Vermont Agency of Transportation

RESUBMIT APPROVED X  
BY KMH DATE 4-12-11

REV.	DATE	REMARKS	DWN	CHK	APVL	SHOP
0	02/25/11	ADDED NOTE	JM	PWR		
MATERIAL:		SURFACE PREP. & PAINT:		HOLES:		SHOP BOLTS:
DESCRIPTION: FRAMING AT WEST & EAST TRUSS ELEVATION						
<b>CASCO BAY STEEL STRUCTURES, INC.</b>						
75 SPRING HILL ROAD			SACO, MAINE 04072			
PHONE (207) 282-7360			FAX. (207) 282-1179			
STRUCTURE: Vermont Route 100A		DRAWN: RB		DATE: 10/11/10		
Bridge No. 14		CHKD: WJL		DATE: 10/19/10		
Bridgewater		JOB NO. 454		DWG NO. E1		
County of Windsor		CUSTOMER: VT AOT		REV. 1

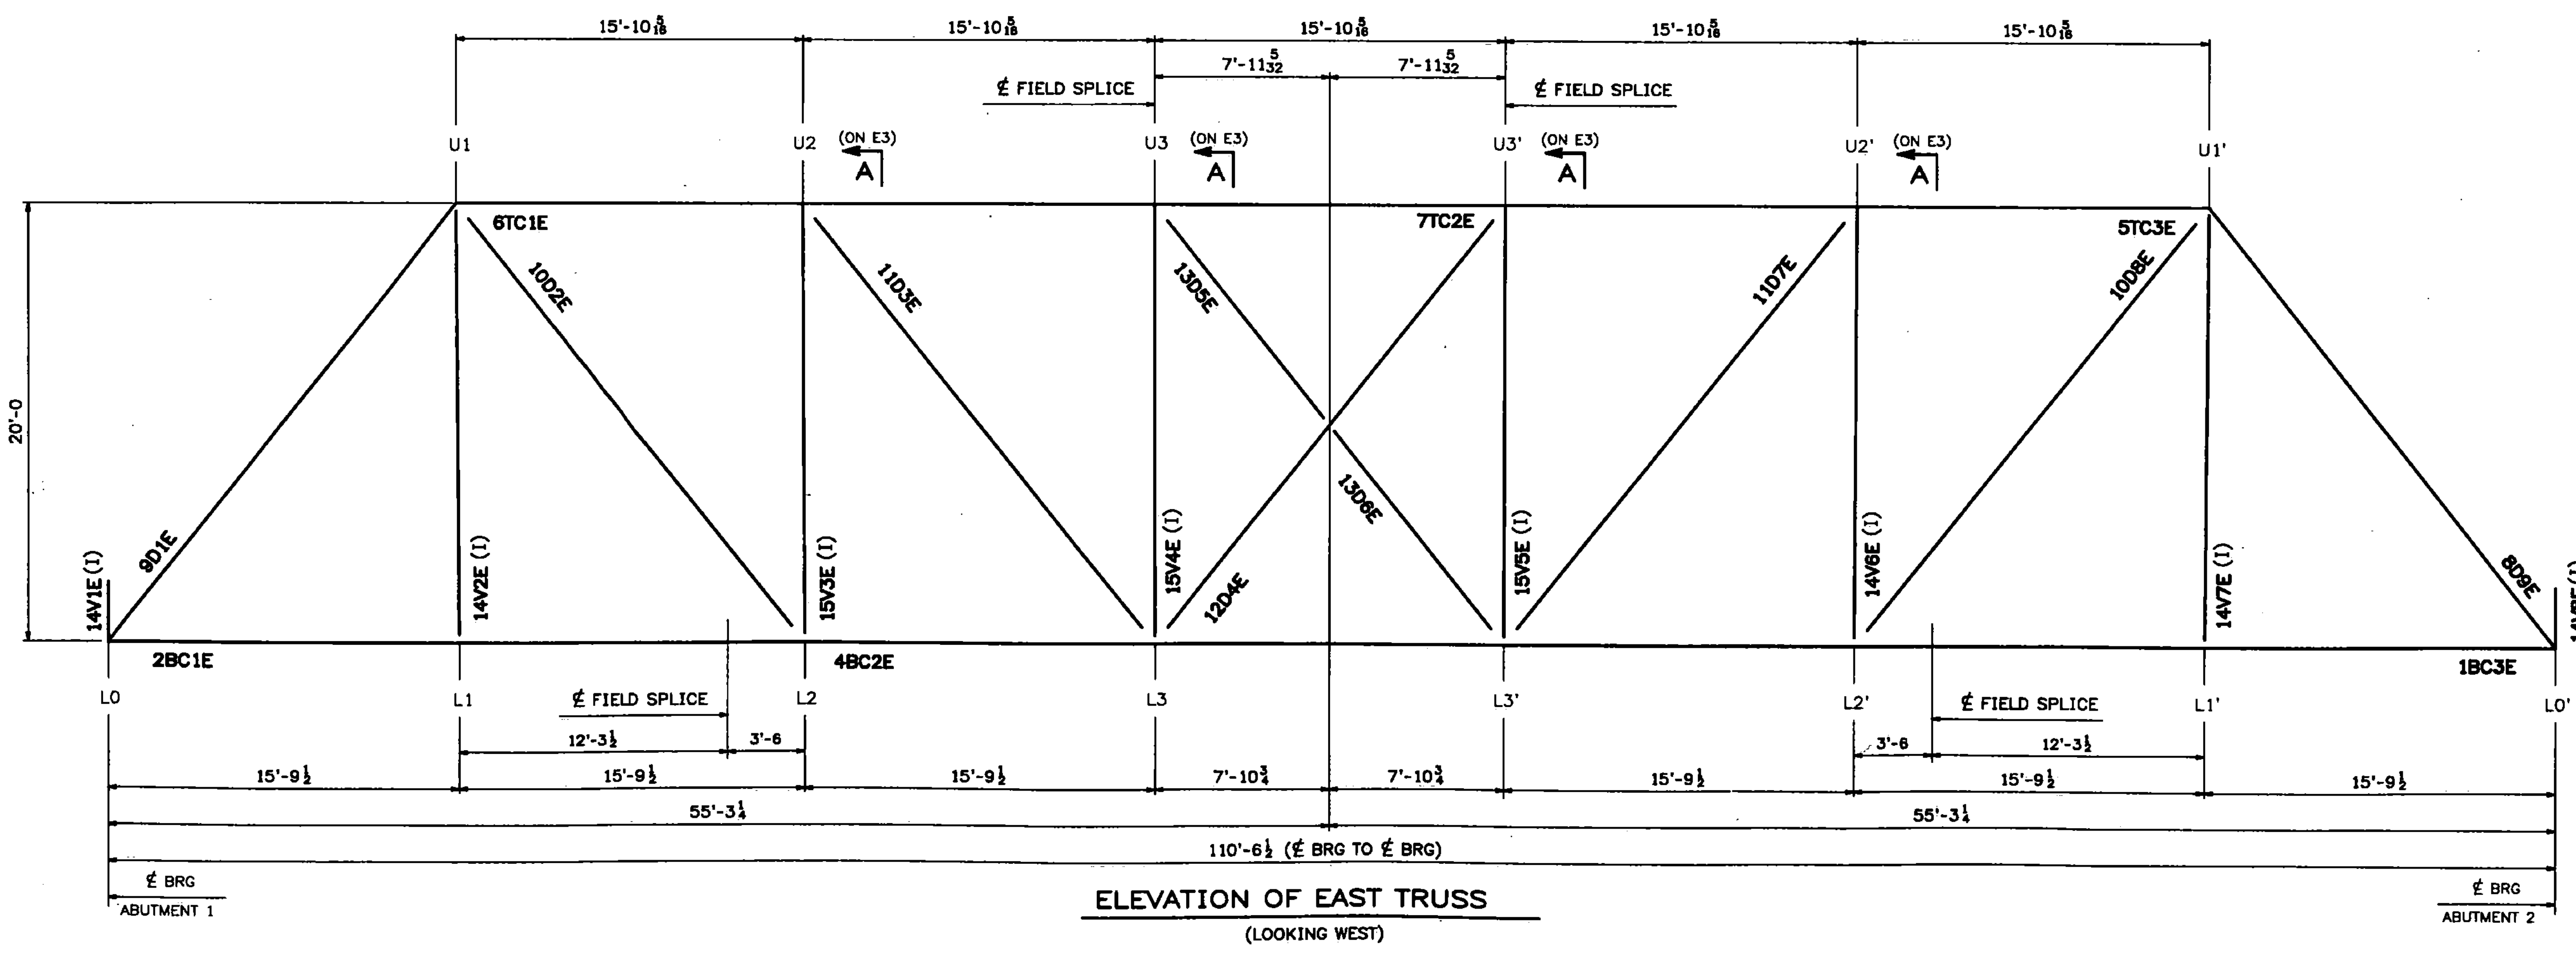
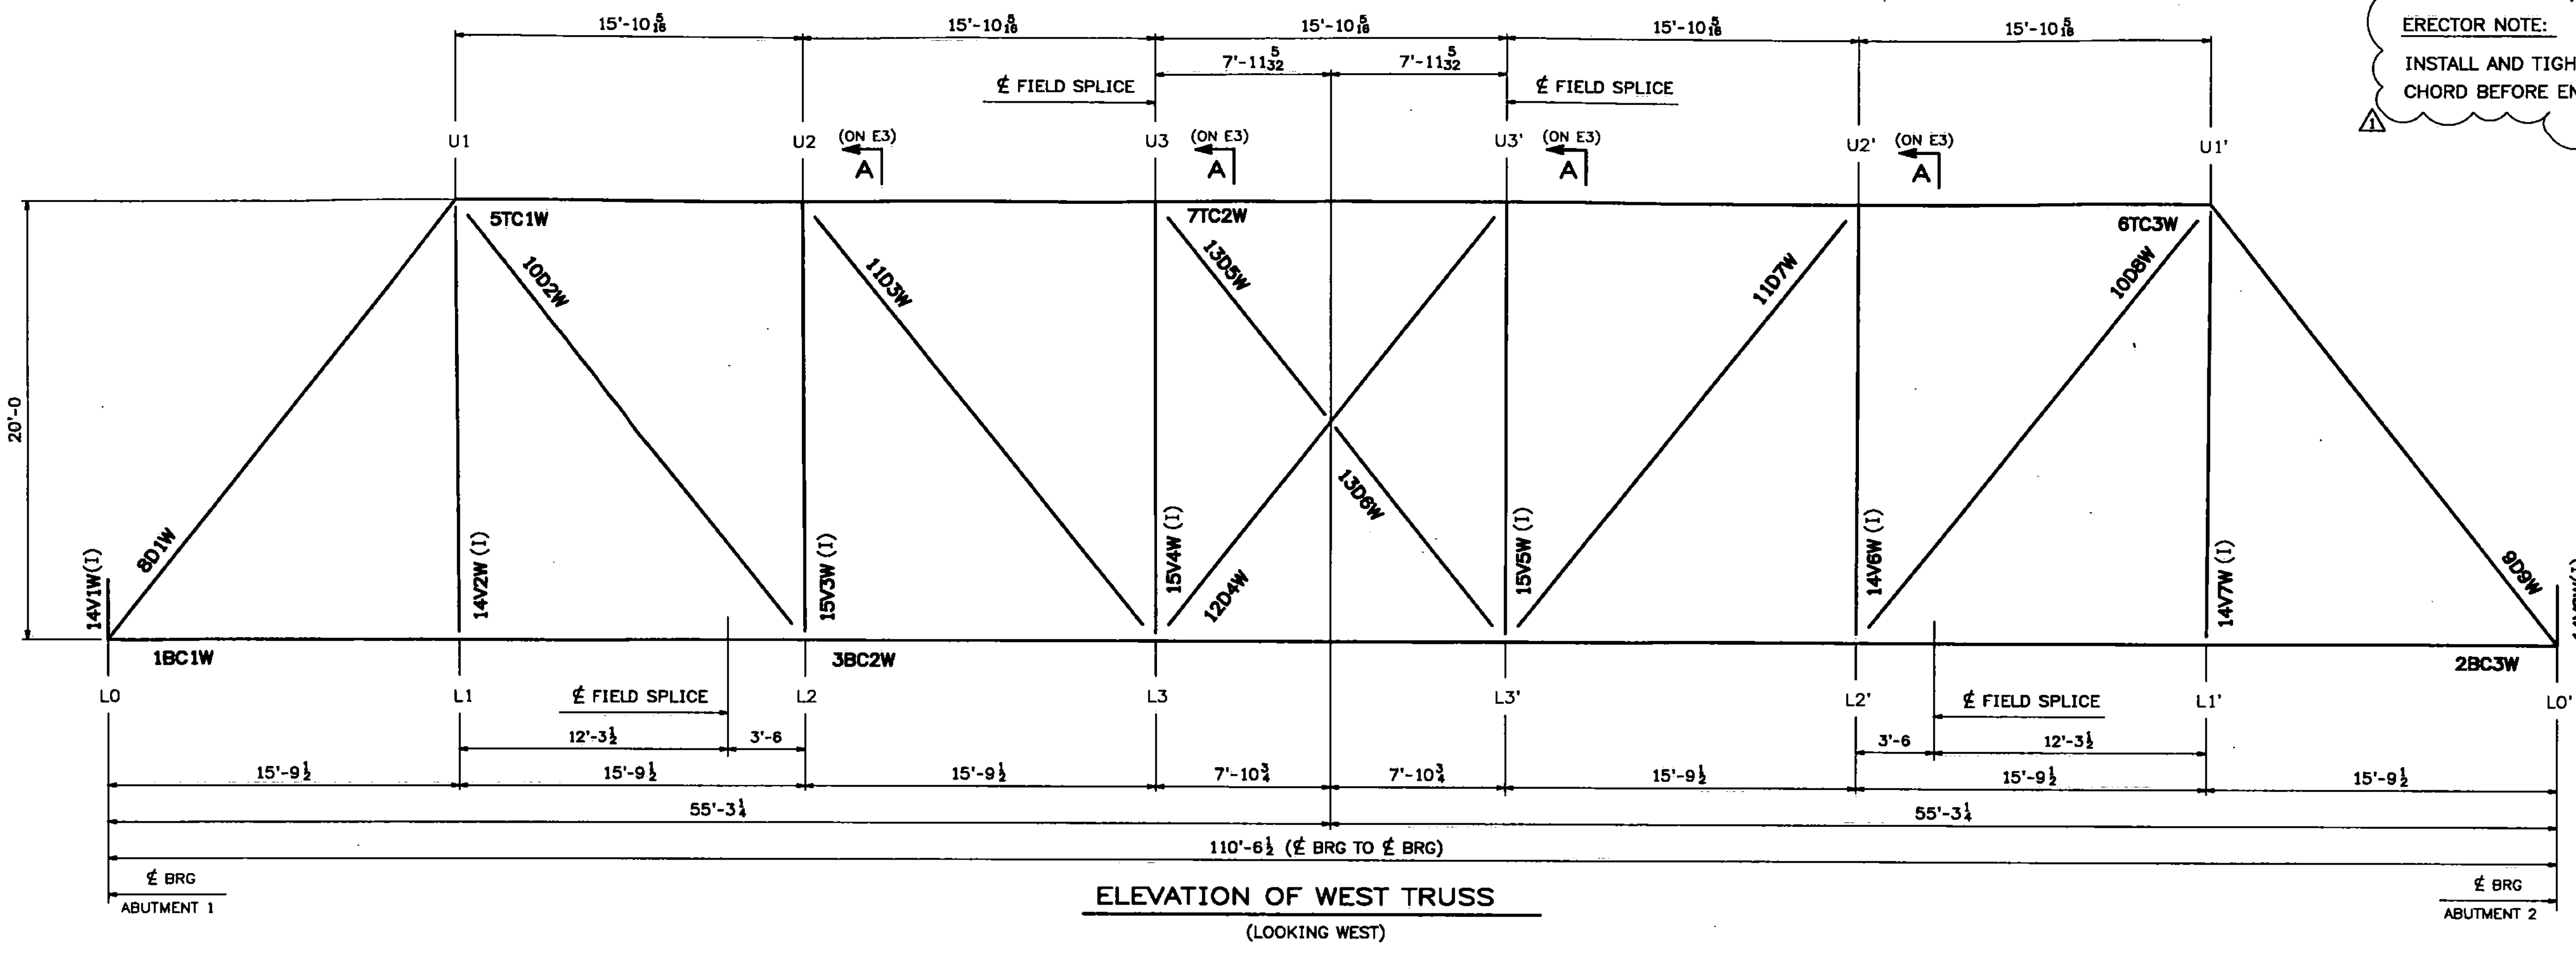
ERECTOR NOTE:  
INSTALL AND TIGHTEN WEB BOLTS OF TOP CHORD BEFORE ENTERING FLANGE BOLTS
